Report Type: Section 4.55 Access Report
Reference Number: 20278
Client: Baini Design
Site Address: 19 Todd Row, St Clair NSW

ACCESS REPORT

This Access Compliance Report is to accompany a Section 4.55 Application for the development proposed at 19 Todd Row, St Clair, NSW.

This development proposes a New Building for the commercial use as a child care centre. The development is within Penrith Council LGA.

Ground floor plan

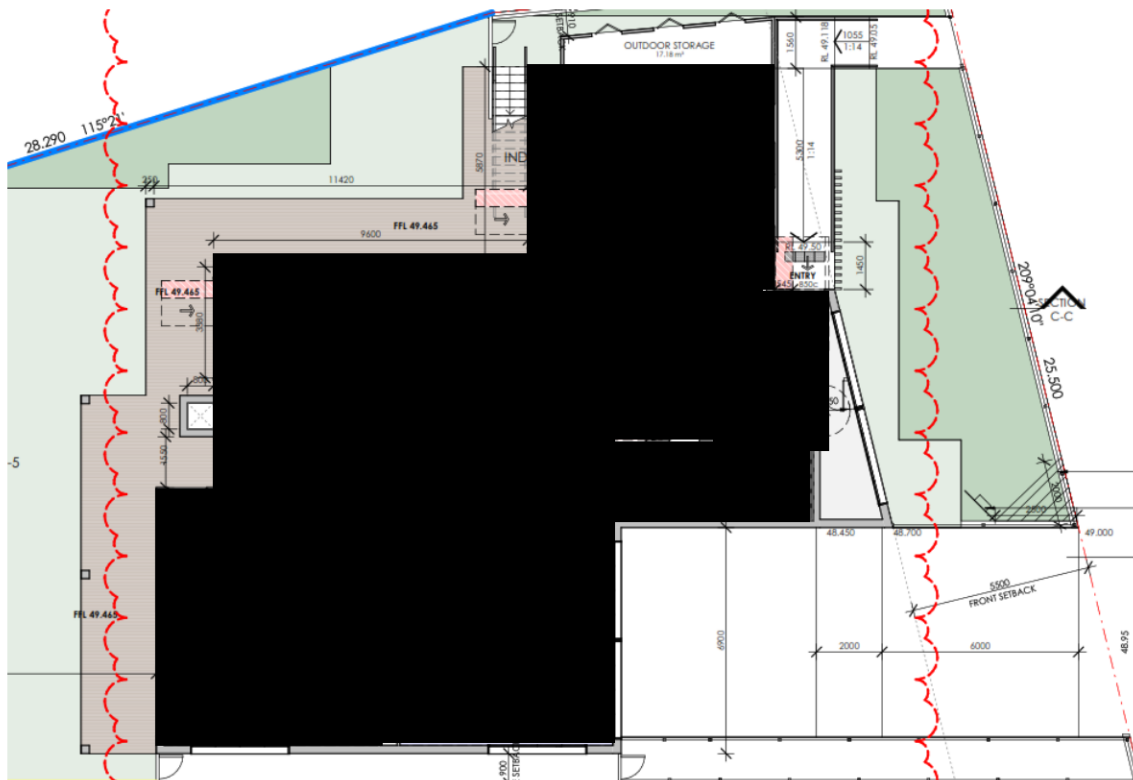
BCA Part F Accessible Sanitary Facilities
	BCA F2.4 Accessible sanitary facilities
Requirement	Accessible unisex toilet is to be provided in accessible part of building such that; <ul style="list-style-type: none"> - It can be entered without crossing an area reserved for 1 sex only - Where male and female sanitary facilities are provided at different locations, Accessible unisex toilet is only required at one of the locations - Even distribution of LH and RH facilities - An accessible facility is not required on a level with no lift / ramp access.
Compliance Comments	<p>Complies.</p> <p>2 unisex accessible facilities have been provided in the development.</p> <p>Ground floor: 1 unisex accessible RH transfer toilet with accessible shower</p> <p>Level 1: 1 unisex accessible LH transfer toilet</p>
